ADDENDUM NO. 03 – April 1, 2024

**RE: Roof Replacement and Associated Work
 at the Center Building
 Augusta, ME
 GALE JN: 839100 P05 T03
 BGS Project Number: 3381**

1 SKYLIGHT INFILL

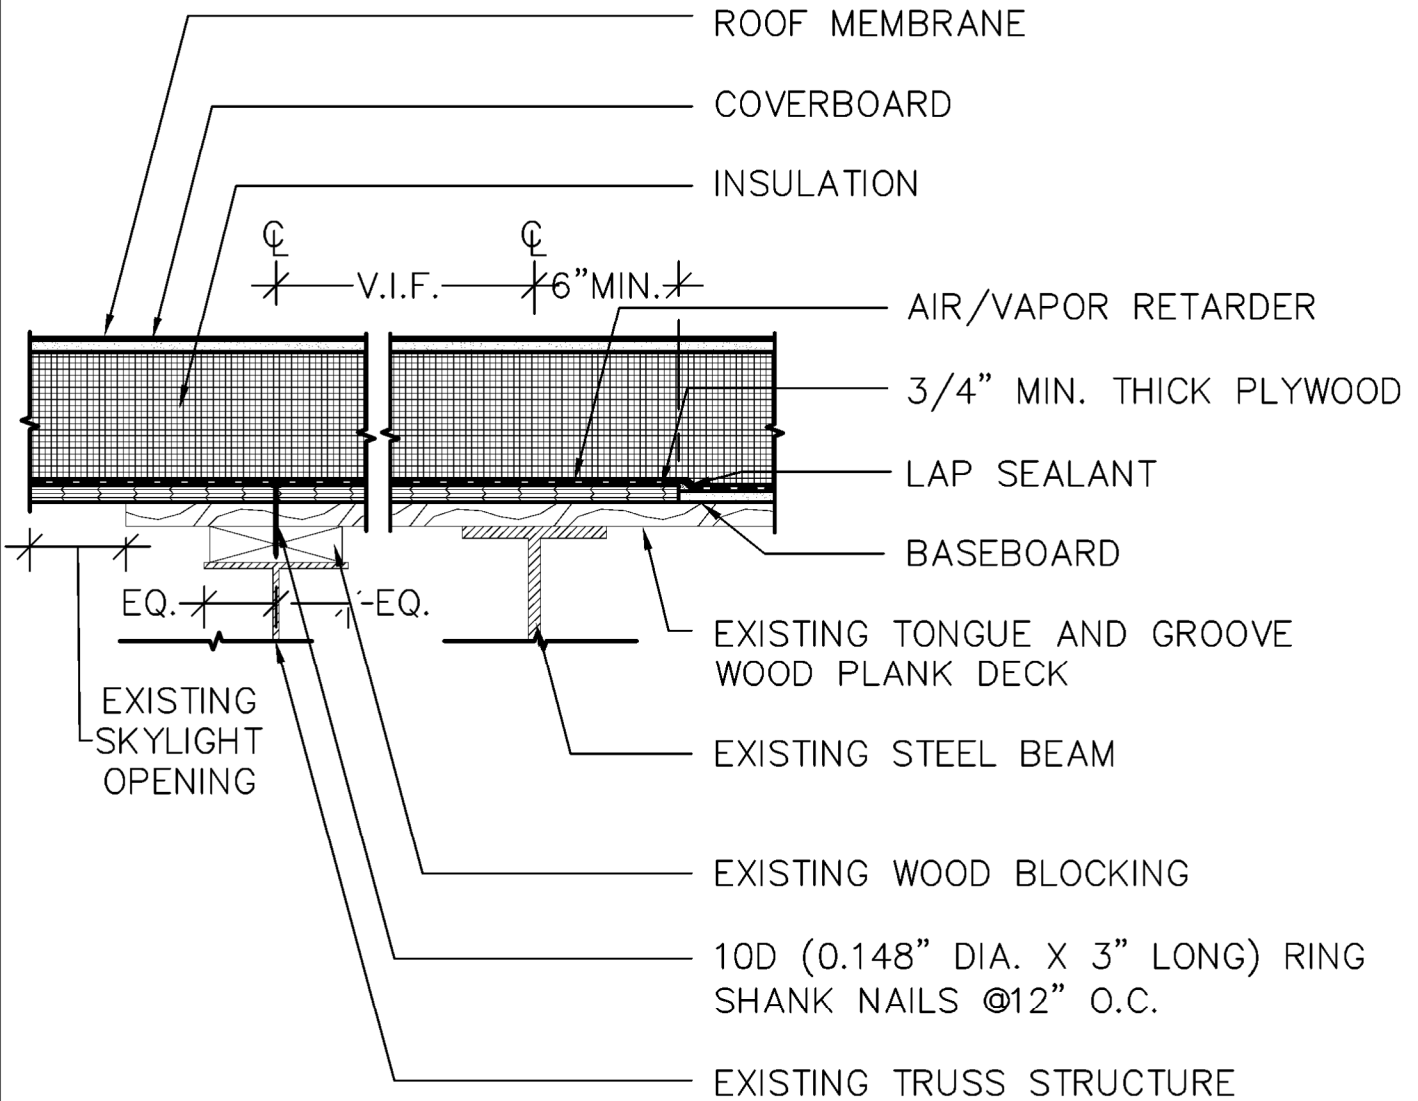
ITEM 1. Skylight Infill Fastening

Reference: Detail 13/A503 Skylight Infill

Clarification: Please refer to the attached SK 04012024 for additional information.

THE BEARING CONDITION AND FASTENING PATTERN SHOWN IS TO BE INSTALLED AT 100% OF THE SUPPORTED SIDES OF THE DECK INFILL.
